PARTS & SERVICE

REF NO.	AT99220A	
DATE	Apr. 27, 2000	
	Page 1 of 18

REPAIR OF CRACK ON CAB FRONT GLASS ON WA120-3--WA470-3

To introduce modification procedures to eliminate cracks occurring in the front windshield glass of the cab on WA120-3 thru WA470-3 wheel loaders

{Reworking procedures for the previous working lamp covers}

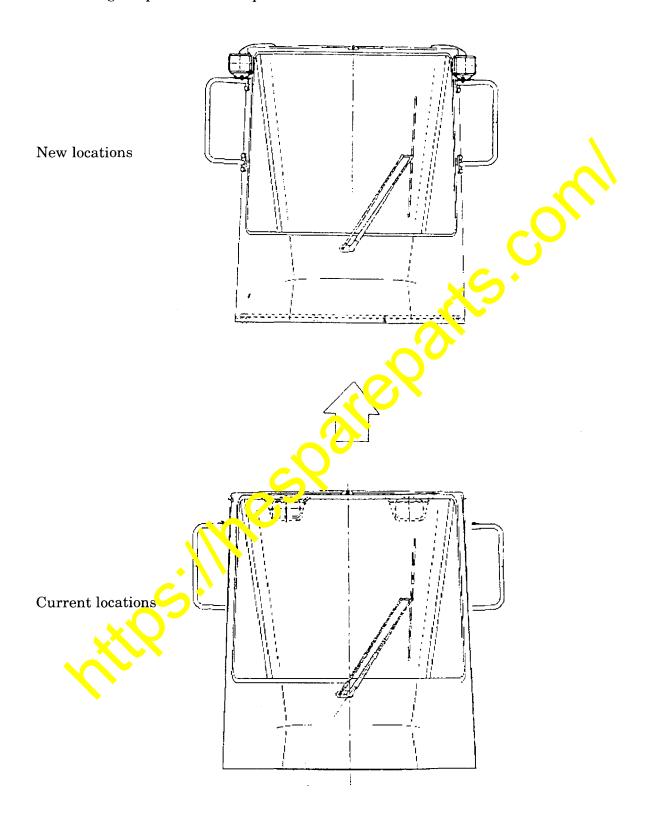
If you have ordered for the previous working lamp covers (425-56-21140, 425-56-21150, 421-926-2960), rework them according to the designations in the schematic diagrams indicated below.

After reworking, their part numbers will be as follows, with their last numbers incremented by one, respectively.

4-1 With WA120-3, WA180-3 and WA180PT-3

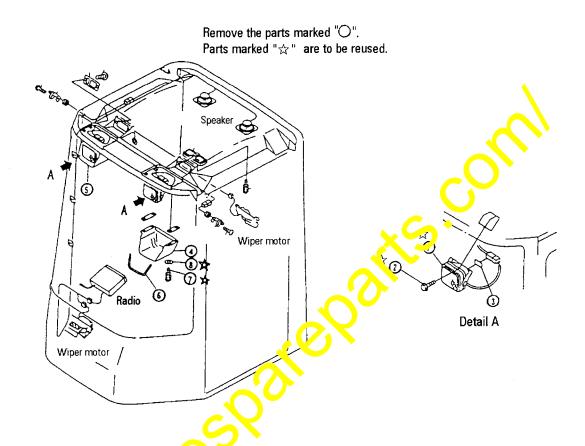
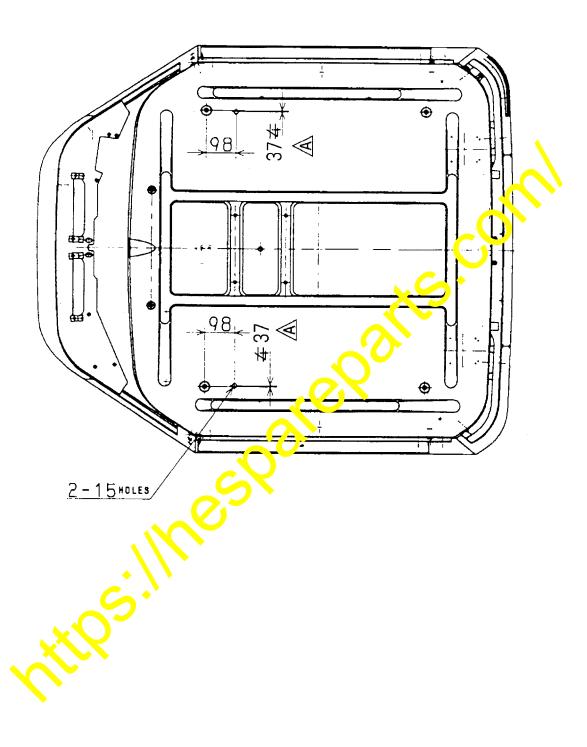
(1) Parts which need to be removed

INDEX	INDEX FALLING. DESCRIPTION		Q'TY	
☆①	42 <mark>1-0</mark> 3-23360	. Lamp ass'y, work	2	
☆②	01435-01220	. Bolt	2	ı
(F)	421-56-21680	. Fastener	4	
(7)	421-56-21330	. Cover, L.H	1	
5	421-56-21340	. Cover, R.H	1	i
6	421-56-21350	. Seal	2	
☆⑦	01023-70512	. Screw	8	
☆8	01642-40608	. Washer	8

(3) Installation

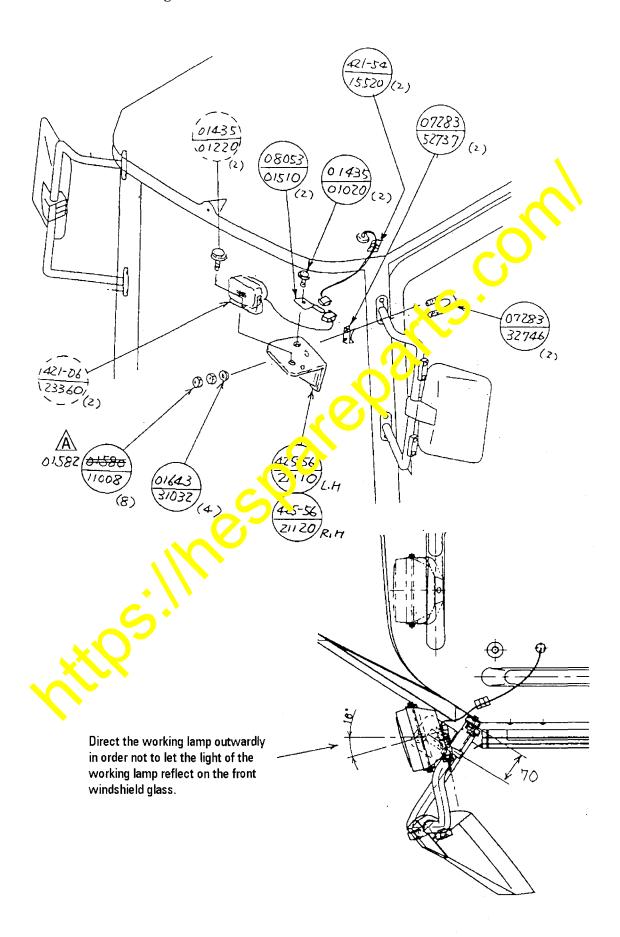
- (1) The connectors (body and holder) marked ** are accessories of the wire harnesses (425-56-21130) and connect them after installing the harness through the cab wall.
- (2) Seal all around the grommet (423-975-1140) and any gap occurring between the harness wire and grommet hole. (Section "P")
 (Use the silicon sealant "THREEBOND 5211E" or an equivalent.)

(1) Parts which need to be removed

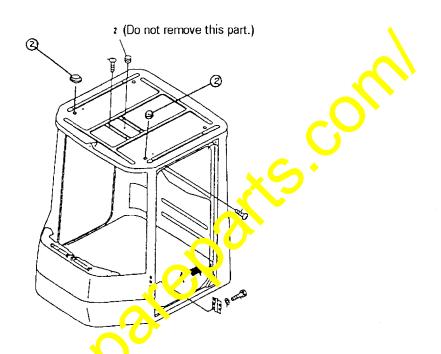
Remove the following parts in addition to what are designated in Section 4-1 (1).

INDEX	PART NO	DESCRIPTION	Q'TY	
2	09415-01008	. Cap	3

- 4-3. With the WA320-3, WA380-3, WA420-3 and WA470-3 (with the serial numbers of 54001 and after)
 - (1) Parts which need to be removed

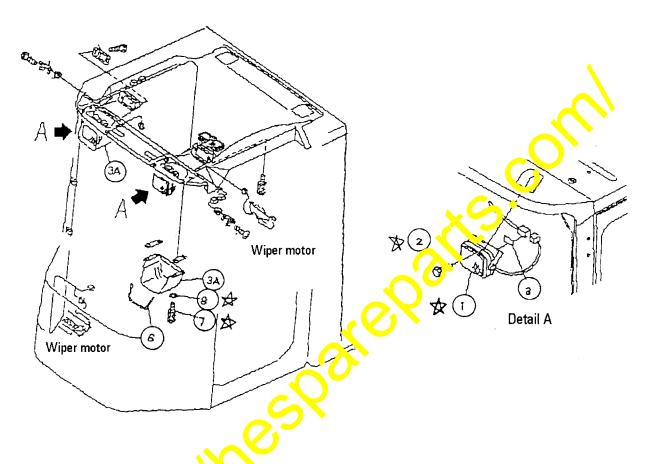
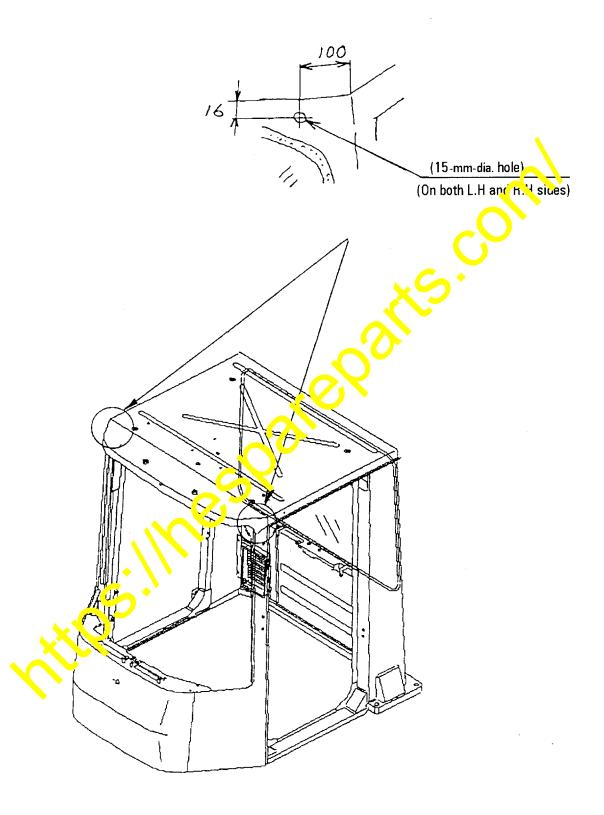
Remove the parts marked \bigcirc . Parts marked \Leftrightarrow are to be reused.

No.	Part NO.	Part Name	Q'ty
☆①	421-96-23360	. Lamp ass'y, work	2
\$ (Z)	61435-01220	. Bolt	2
3	421-56-21680	. Fastener	4
(3A)	424-926-2260	. Cover	2
6	421-56-21350	. Seal	2
☆⑦	01023-70512	. Screw	8
\$8	01642-40608	. Washer	8

(3) Assembly

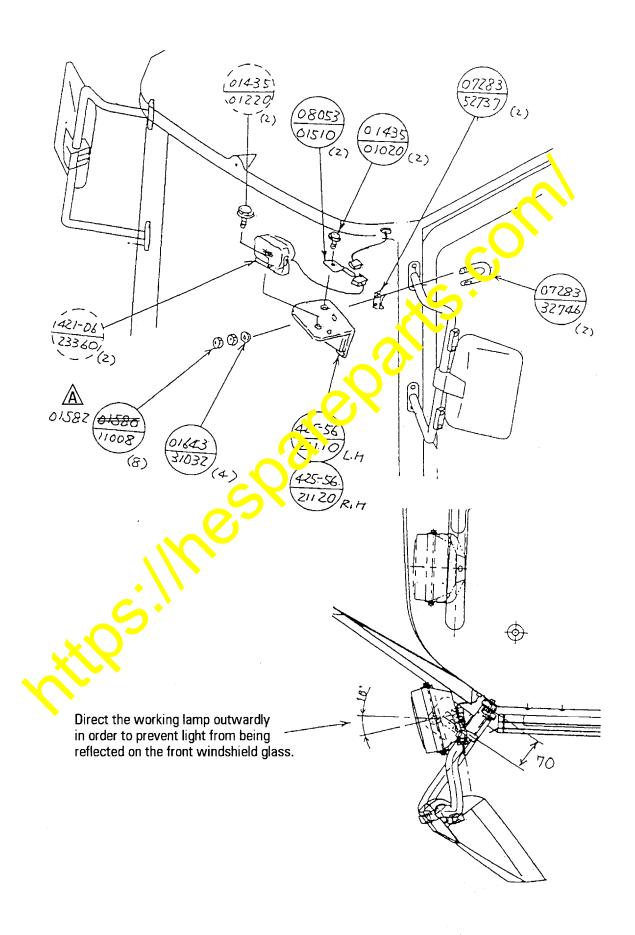
- (1) The connectors (body and holder) marked \times are accessories of the wire harnesses (425-56-21130) and connect them after installing the harness through the cab wall.
- (2) Seal all around the grommet (423-975-1140) and any gap occurring between the harness wire and grommet hole. (Section "P")

(Use the silicon sealant "THREEBOND 5211E" or an equivalent.)

4-4 Windshield glass replacement procedures

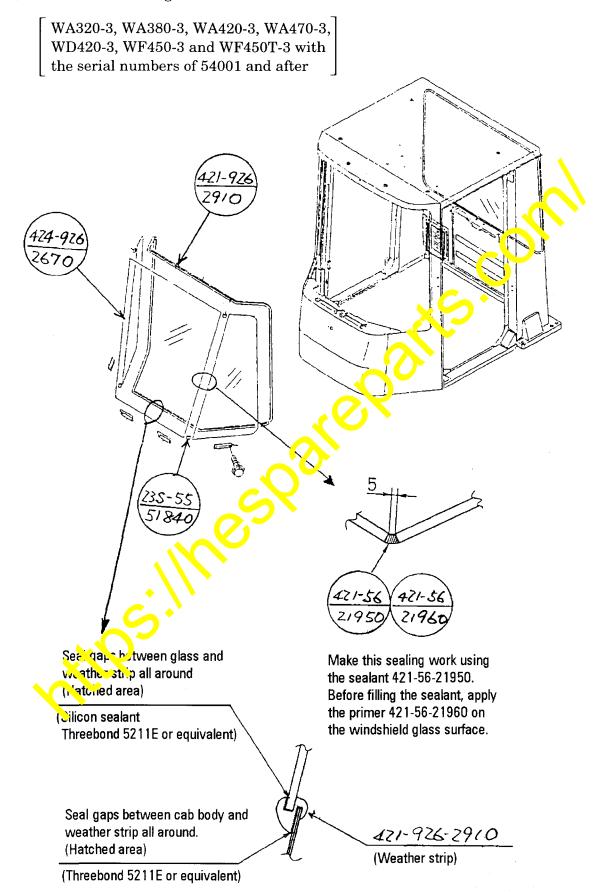
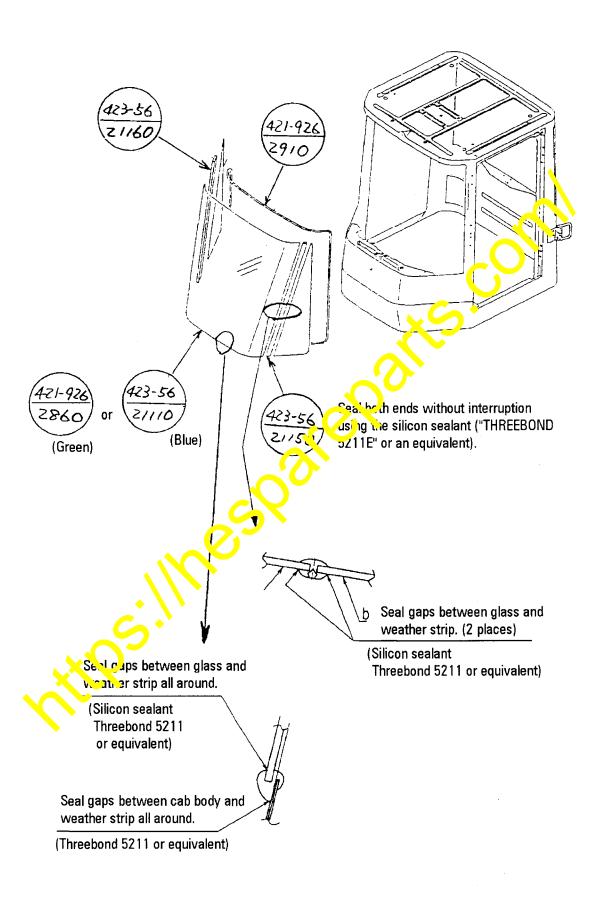
(1) With the following models

(2) With other models than what have been indicated on the preceding page.
